Title - Sujet Equipment Maintenance Building	
Solicitation No. - N° de l'invitation EZ899-181343/A	Amendment No. - N° modif. 003
Client Reference No. - N° de référence du client	Date 2017-11-21
GETS Reference No. - N° de référence de SEAG PW-\$PWY-022-8224	
File No. - N° de dossier PWY-7-40239 (022)	CCC No./N° CCC - FMS No./N° VME
Solicitation Closes - L'invitation prend fin at - à 02:00 PM on - le 2017-11-29	Time Zone Fuseau horaire Pacific Standard Time PST
F.O.B. - F.A.B. Plant-Usine: <input type="checkbox"/> Destination: <input checked="" type="checkbox"/> Other-Autre: <input type="checkbox"/>	
Address Enquiries to: - Adresser toutes questions à: Arthur (PWY), Carolyn	Buyer Id - Id de l'acheteur pwy022
Telephone No. - N° de téléphone (604) 364-2752 ()	FAX No. - N° de FAX (604) 775-6633
Destination - of Goods, Services, and Construction: Destination - des biens, services et construction: TC - Port Hardy Airport - Port Hardy, BC

This amendment 003 is raised to:

- 1) Incorporate Addendum No. 1

PROJECT: PORT HARDY AIRPORT EQUIPMENT
MAINTENANCE BUILDING

DRAWING NO:
AE-01 - ESK-01

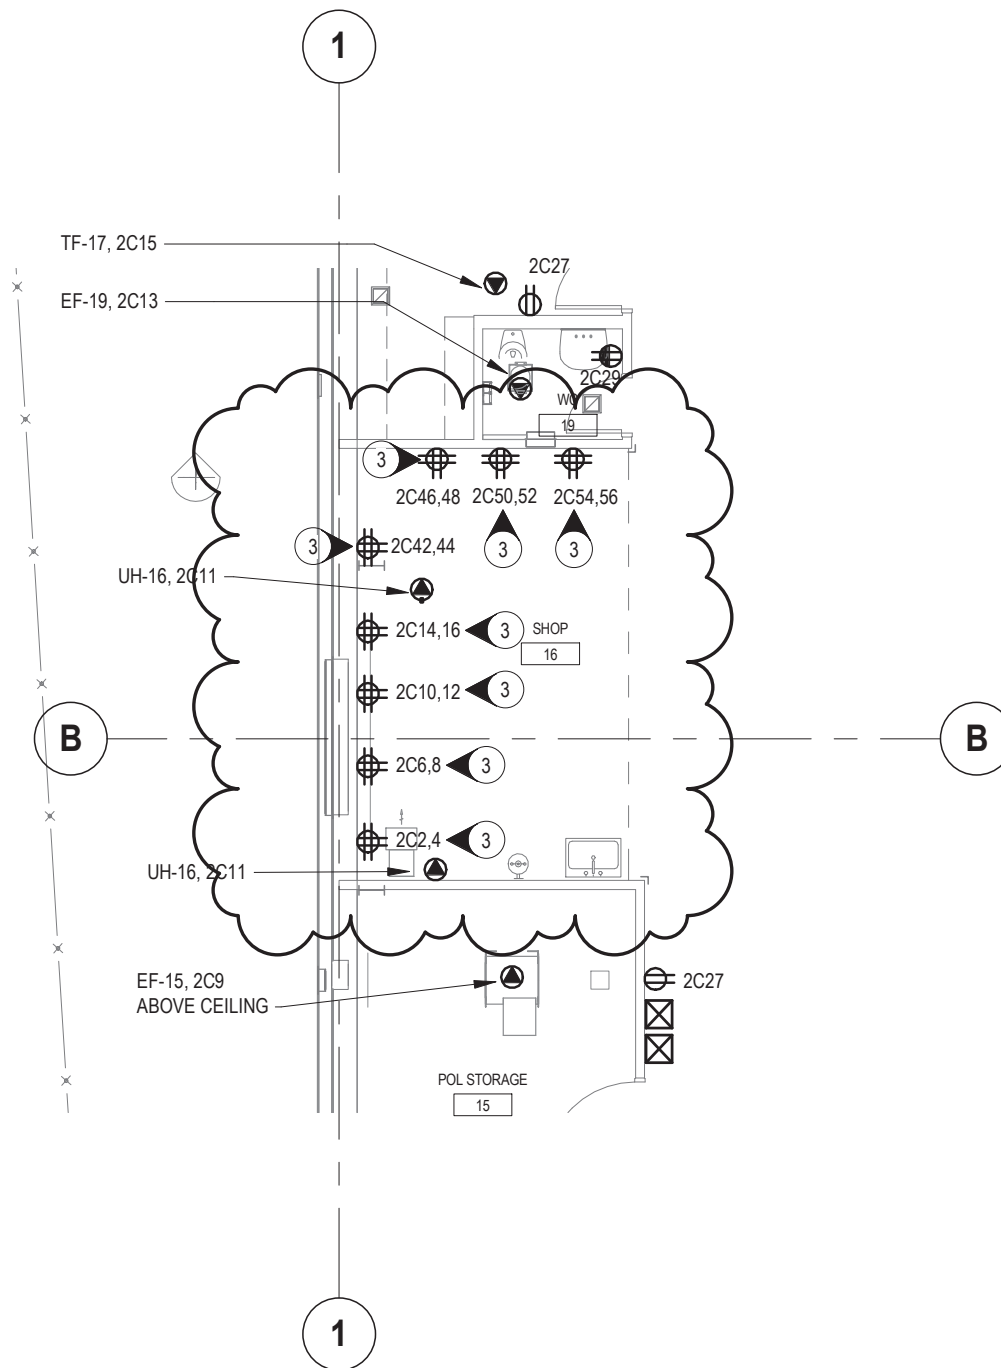
- .1 Communications conduit to terminate into an in-ground pull box. Refer to attached electrical sketch ESK-01.
- .2 Cut sections refer to details on this drawing (E-001) and not E-100.

DRAWING NO:
AE-01 - ESK-02

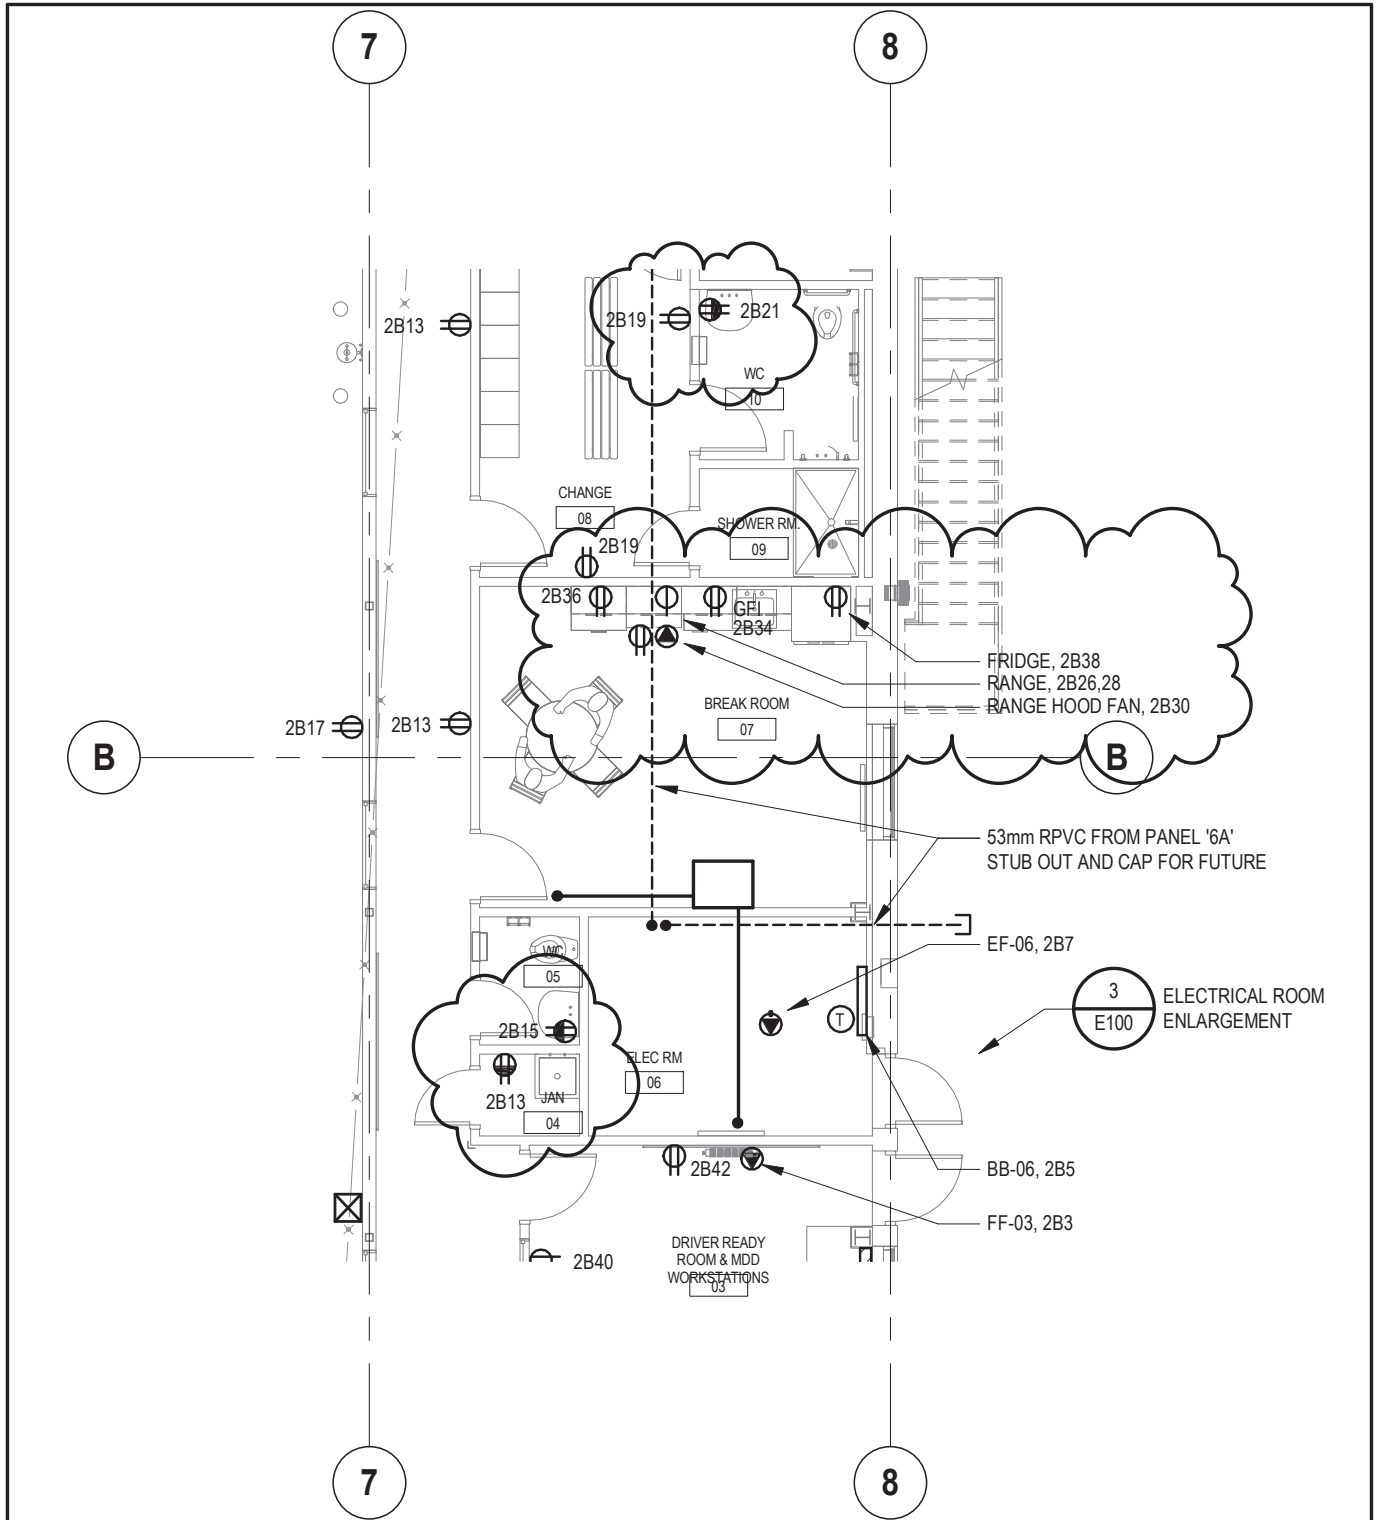
- .1 FA Bells, security and motion detectors by the exit door have been removed from this drawing. Refer to drawing E-101 for system devices.
- .2 Shop 16, all receptacles have been revised to four-plex receptacles c/w a dedicated circuit on each duplex (2 per 4-plex). Refer to attached electrical sketch ESK-02.

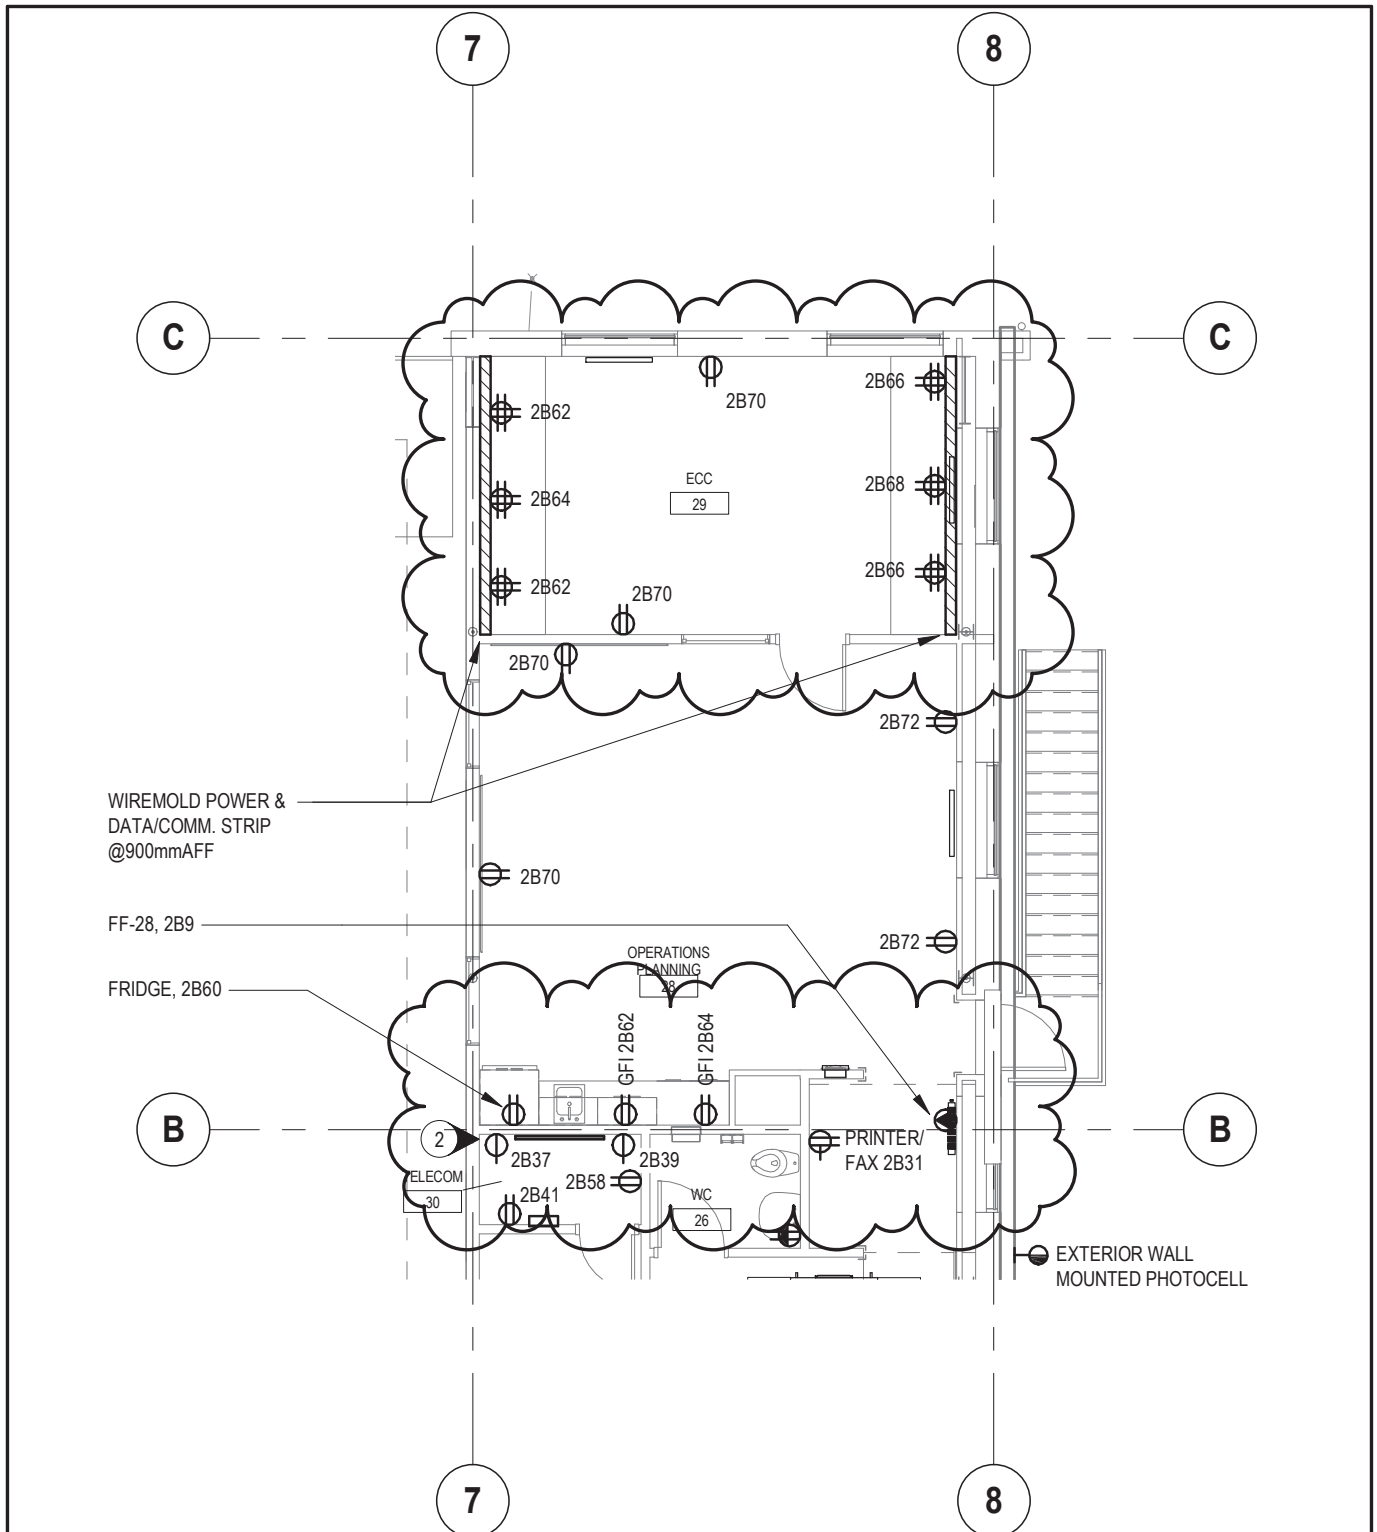
- .3 Janitor room, receptacle revised to GFI type. Refer to attached electrical sketch ESK-03.
- .4 Light switches and occupancy sensor have been removed from this drawing. Refer drawing E-102 for lighting layouts.

- .5 Range receptacle in Break Rm. 07 has been identified. Refer to attached electrical sketch ESK-03.
- .6 WC10, receptacle located onto west wall. Refer to attached electrical sketch ESK-03.

DRAWING NO:
AE-01 - ESK-04

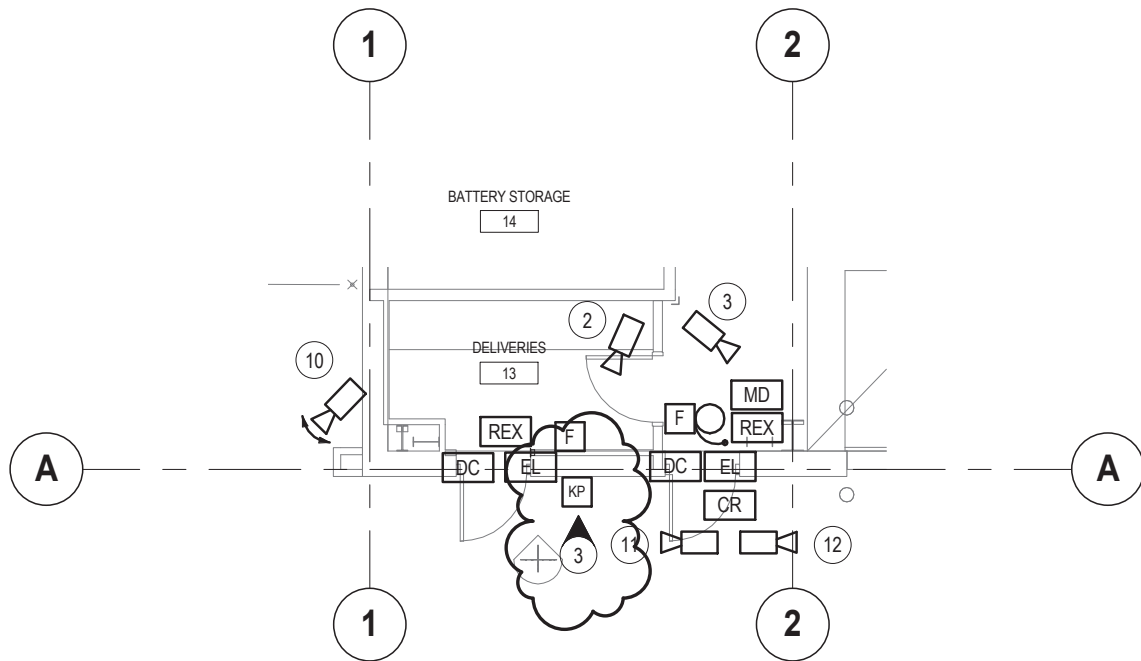
- .7 Operations Planning counter receptacles have been revised to circuited to one circuit per GFI receptacle. Refer to attached electrical sketch ESK-04.

- .8 Printer / Fax receptacle has been revised to a 20A T-slot receptacle. Refer to attached electrical sketch ESK-04.
- .9 FF-28, Force flow heater revised location. Refer to attached electrical sketch ESK-04.

- .10 Telecom Rm. To be c/w two (2) 120V, 15A Twistlock Receptacle. Refer to attached electrical sketch ESK-04. Exact location to be confirmed on site with SSC communication contractor prior to roughin.

- .11 ECC room, all receptacles revised to 4-plex c/w a dedicated circuit to each one. Refer to attached electrical sketch ESK-04.

DRAWING NO:
AE-01 - ESK-05

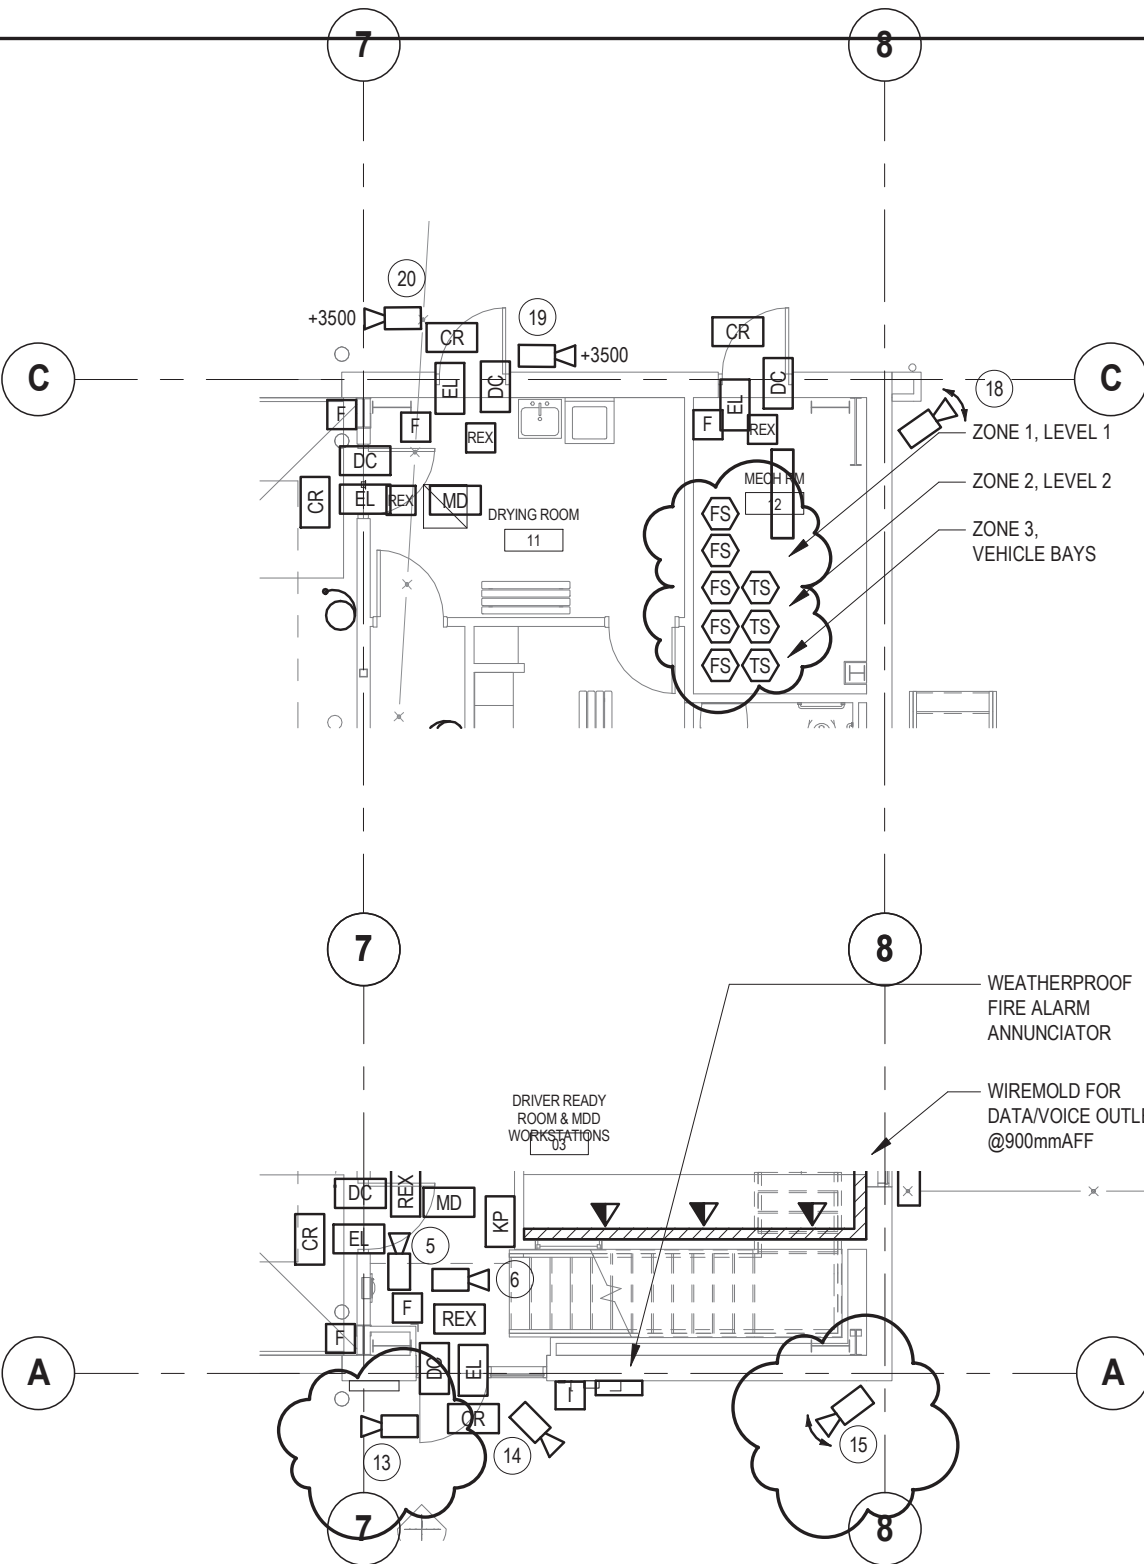
- .2 Delivery room security access keypad / card reader combo (KP), refer to keynote #3 for clarification, electrical sketch ESK-05.
- .3 Security cameras at main entrance on level 1 revised, refer to electrical sketch ESK-06.

- 1 WALL MOUNTED INTERCOM STATION CONNECTED TO MAIN ENTRANCE INTERCOM STATION
- 2 WALL MOUNTED MAIN ENTRANCE DOOR RELEASE PUSHBUTTON.
- 3 SECURITY ACCESS KEYPAD - CARD READER COMBINATION DEVICE FOR SECURED ACCESS TO DELIVERY ROOM.

DRAWING NO:
AE-01 - ESK-06

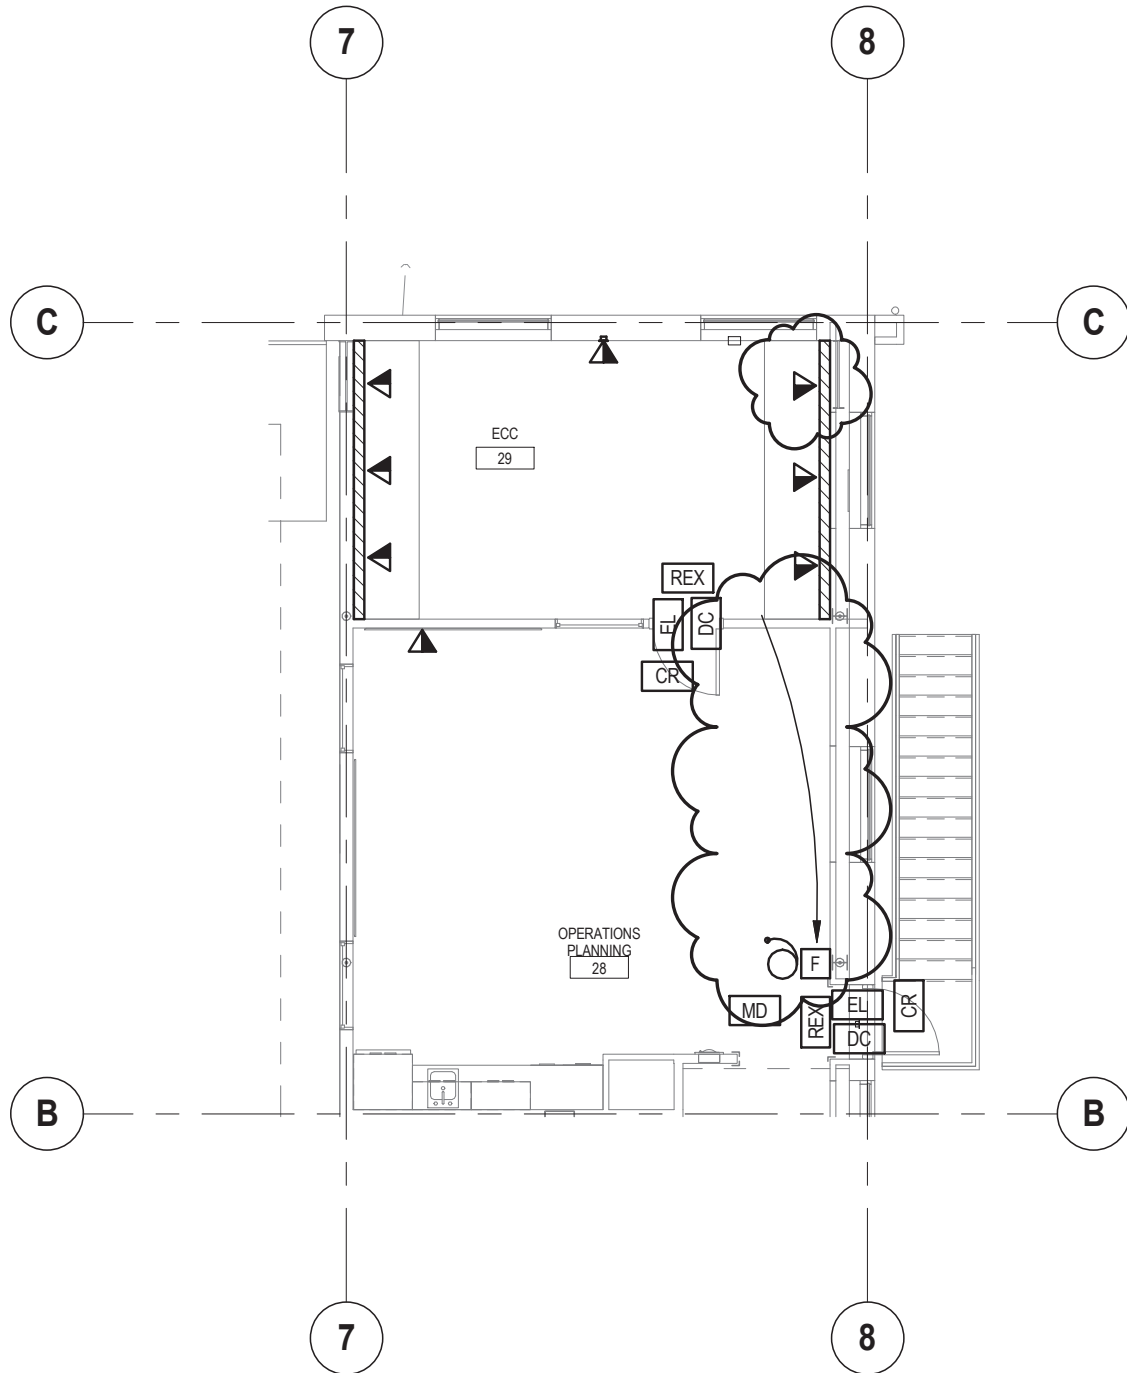
- .4 Add two tamper switches for double check valves to mechanical rooms, nomenclature for sprinkler Tamper switches revised to `TS' for consistency between disciplines, refer to electrical sketch ESK-06.
